## Habanero Product Change Notification

PCN Tracking: HAB-0001\_v1.0

### 8devices Habanero RF shield upgrade notification

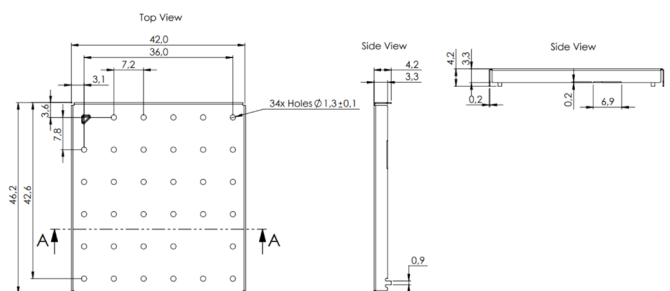
Old RFFM8528TR7 no longer available at reasonable price, no pin to pin alternatives available. Introducing new 5Ghz FEM, Part number SKY85716-11. New Habanero module is pin to pin compatible with current version.

Introducing clip-in shields for quality improvement as a proactive and effective step in enhancing the quality control process on our production line. AOI will help identify defects and inconsistencies in manufactured products, which is crucial for maintaining high-quality standards.

Tests showed that there is no negative impact to the Rf side. Test results available on request.

Devices will certify new design modules by the end of 2026.
